SUBJECT: ISSUANCE OF AMENDMENT NO. 140 TO FACILITY OPERATING LICENSE  
NO. DPR-51 - ARKANSAS NUCLEAR ONE, UNIT NO. 1 (TAC NO. 74894)

SAFETY EVALUATION BY THE OFFICE OF NUCLEAR REACTOR REGULATION

RELATED TO AMENDMENT NO. 140 TO

ARKANSAS NUCLEAR ONE, UNIT NO. 1

## FIGURE 2 PLANNED MODIFICATION

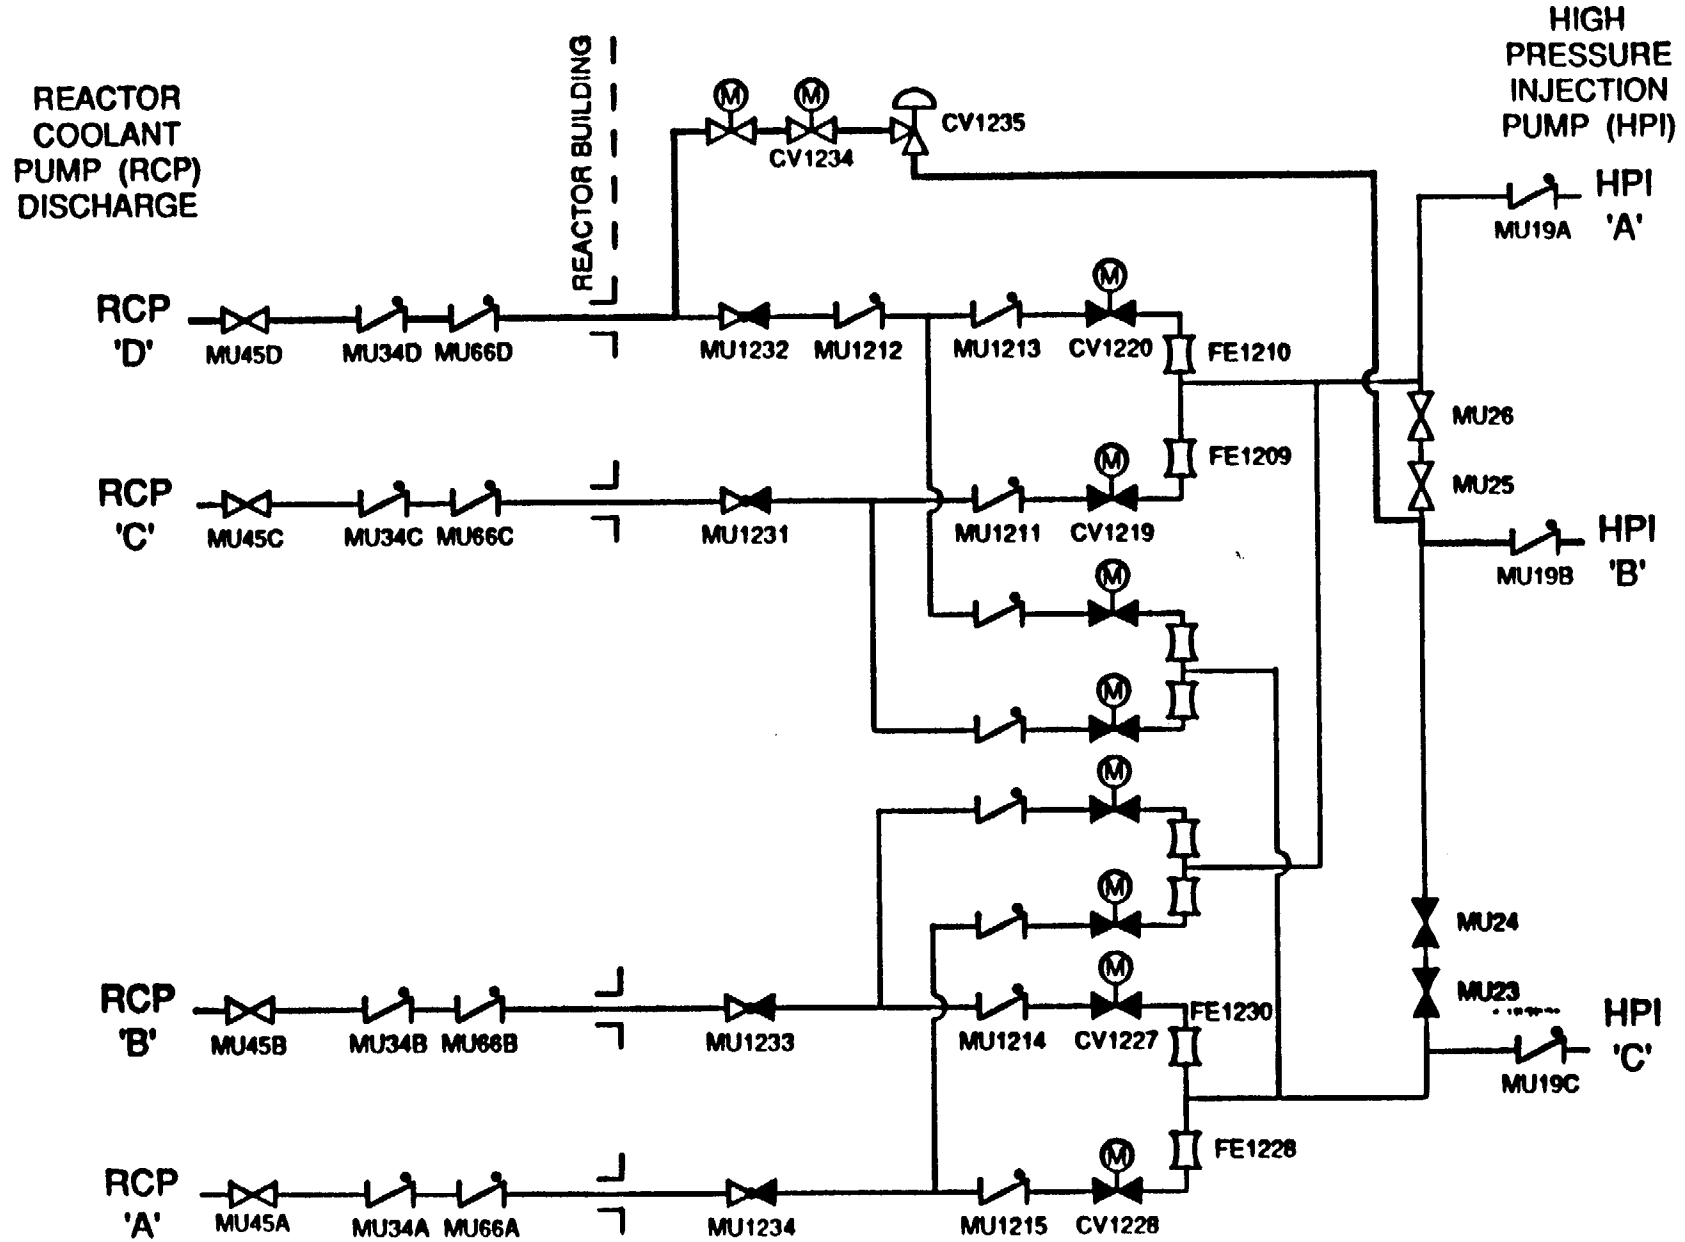
The specific small break LOCA addressed with the HPI system piping modifications analysis and testing is the HPI line break, between the RCS connection and the first HPI line check valve. The proposed arrangement is shown in Figure 2 and includes four additional injection lines with throttling isolation valves and flow instrumentation (flow indicators) powered by the same train of safety grade power as the pump which supplies them. With this modification each injection pump will be able to supply borated water through four lines with individual flow indication and throttling isolation valves. Given any

single failure, this arrangement allows a broken line to be throttled independently to enable the intact lines to provide adequate HPI flow. This arrangement will incorporate twice as many flow lines as previously with an equal number of flow meters equipped with safety grade chart recorders (Regulatory Guide 1.97, Type A, Category 1). Manual globe valves in the new lines will be pre-throttled to provide a balanced system flow.

- ° EOP guidance will direct the operator to throttle the high injection flow line to within 20 gpm from the next highest flow injection line
- ° Each line will be provided with high point vents and low point drain
- ° Post installation testing will confirm the pre-throttled flow
- ° The new valves will be tested to ASME Section XI
- ° The pumps will continue to be tested for degradation to ASME Section XI

The staff concludes that the proposed HPI arrangement provides adequate flow for the limiting HPI line break and meets existing requirements for steam line break and generator tube rupture. Therefore, the staff finds it acceptable subject to confirmation of its performance with post implementation testing.
